ExQ1	Question to:	Question:
1. General and cross-topic questions		
Q1.2.1		No further questions at this time
2. Development consent order [REP3-004] clean [REP3-005] tracked		
Q2.2.1	The applicant	<p>Inspection of documents</p> <p>The explanatory note at the end of the draft Development Consent Order (dDCO) states that documents will be available for inspection at a third party location. As this location is currently blank, the applicant is asked to confirm how this will be confirmed, including securing third party agreement to this.</p>
Articles		
Q2.2.2	The applicant	<p>Article 9 Defence to proceedings in respect of statutory nuisance</p> <p>a. Despite the widespread precedent for this article, at least in some form, what could be the practical implications of removing this power on the construction, operation or maintenance of the authorised development if the Order is made?</p> <p>b. The ExA notes that Newark and Sherwood District Council (NSDC) is in favour of its removal, [REP3-105]. The Examining Authority (ExA) asks the applicant to provide examples of where the construction, operation or maintenance of any authorised development has been affected by the use of 82(1) (summa

Group F Road users between Ossington and the A1/Carlton on Trent

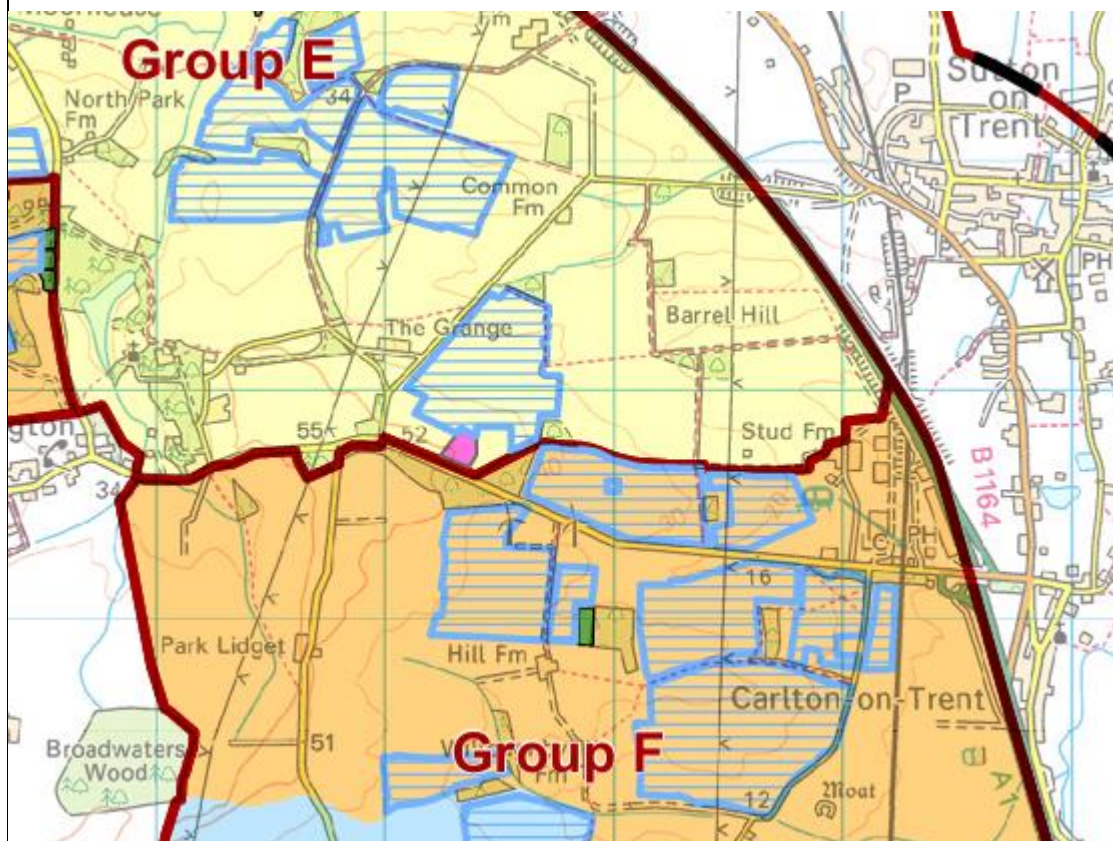
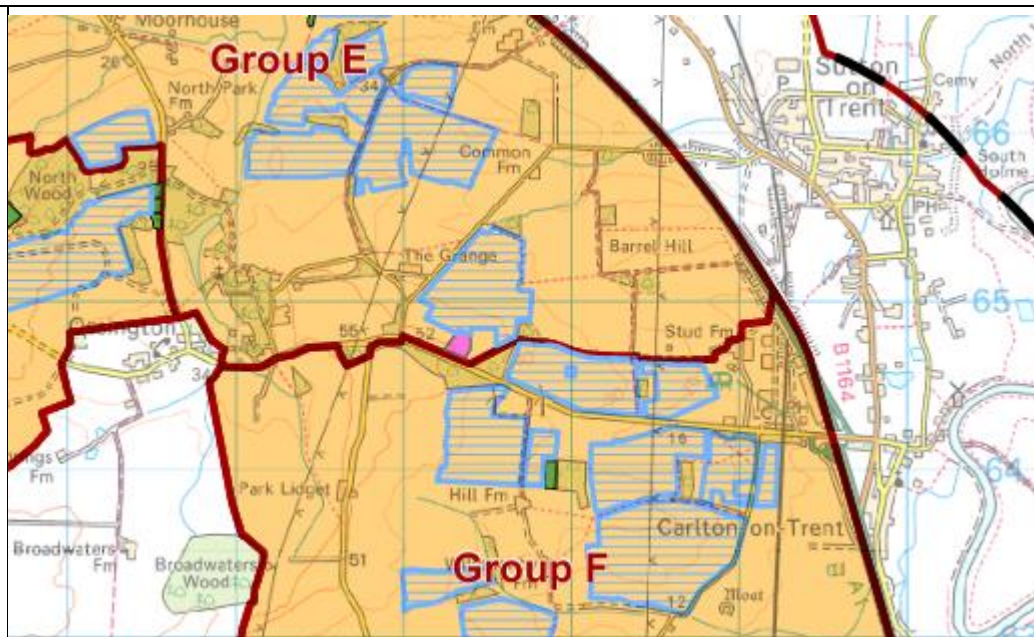
This is with reference to the most northerly aspect of this part of Group F on the north and south side of Ossington road where the solar arrays will form an almost continuous experience – especially around Carlton on Trent. This is due to the open nature of the views across this landscape It is between Ossington and Carlton (not Thornton) and it is along Ossington Road. This is indicated in the mapping extracts below.

During construction and early operation this group is judged to be Major/Moderate which will be significant

During operation and decommissioning Major/Moderate adverse which will be significant
